Product Change Notification / RMES-21CWWT073

CCB 4629 Final Notice: Qualification of STA as an additional assembly site for LAN7500x, LAN8820x and LAN9730x device families available in 56L VQFN (8x8x0.9mm) package.

CCB 4629
Pre and Post Change Summary
PCN#: RMES-21CWWT073

ASE

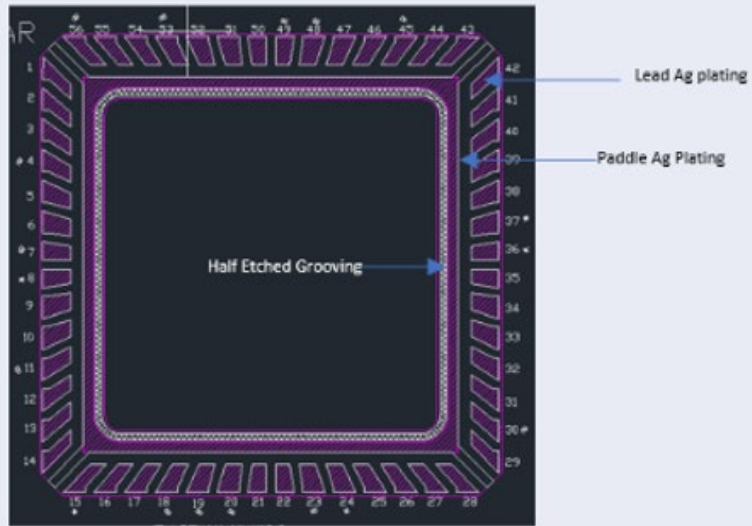
LF Definition – Double Ring Plating

*Plating on Lead finger and plating surrounding LF Paddle (Purple shaded area)

Lead frame Paddle size	240 x 240 mils
------------------------	----------------

STA

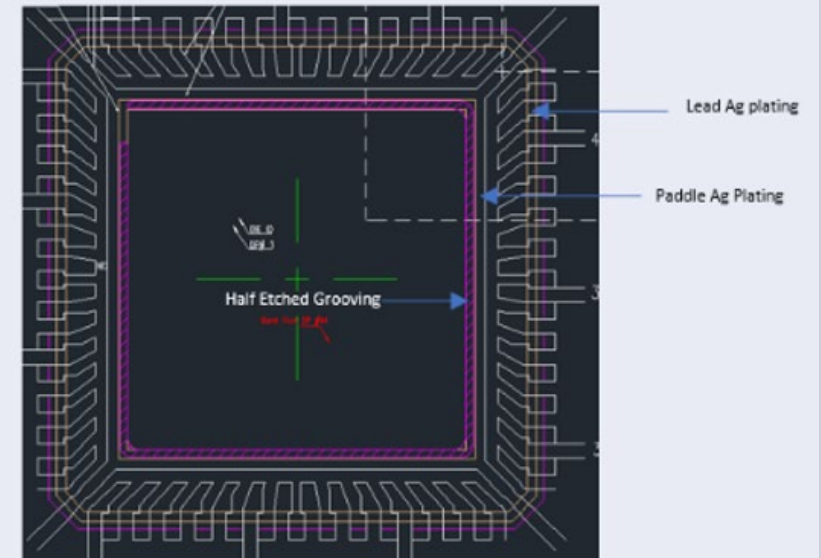
LF Definition – Double Ring Plating

*Plating on Lead finger and plating surrounding LF Paddle (Yellow outline area)

Lead frame Paddle size	236 x 236 mils
------------------------	----------------
